**GRE Informal Working Group on
Simplification of the UN Lighting and Light Signalling Regulations (SLR)**

36th meeting

8-10 January 2020

REPORT

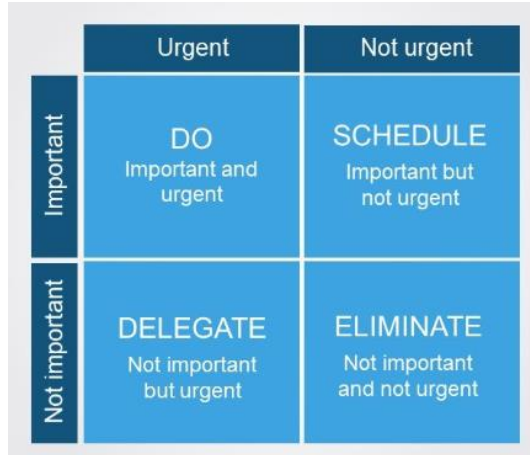
The SLR discussed what could be the most appropriate logic to assign the priority to the GRE list of current and future work items, as indicated in document SLR-34-06/Rev.3. It was also considered what would be the most suitable format to present the GRE priorities to WP.29.

The so called “Eisenhower Matrix” was considered as one of the possible tools to help prioritising the items by urgency and importance:

The SLR agreed that, the GRE work items listed in doc. SLR-34-06/Rev.3 will be used by Mr. Loccufier and Mr. Rovers (GRE Chairs) to produce a priority table based on the format used in doc. GRSP-66-39/Rev.5. The SLR observed that this document was prepared by GRSP using the template provided by the Secretariat to the Chairs of GRs, following the AC.2 instructions given at the 179th WP.29 session (see ECE/TRANS/WP.29/1149, para 8.).
